Title:	Casters STX1000			ID:
				0305
Date in:	Response:	Model:	Author:	
2007-09-05	2007-09-05	STX1000	CMa

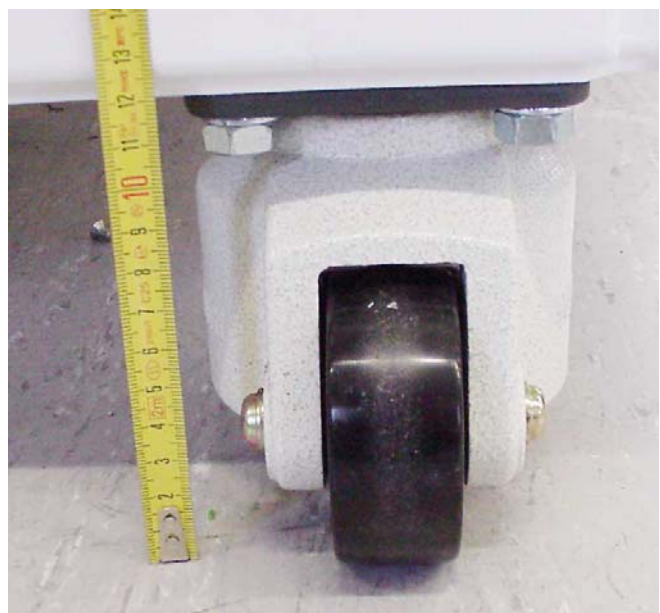
Does Liconic have smaller diameter casters for STX1000?
We need something smaller to lower the unit.

We once used smaller casters but with them the Unit was nearly impossible to move. Currently we have two designs which are out in the field.

Old design with a height of 125 mm

New design with a height of 120 mm
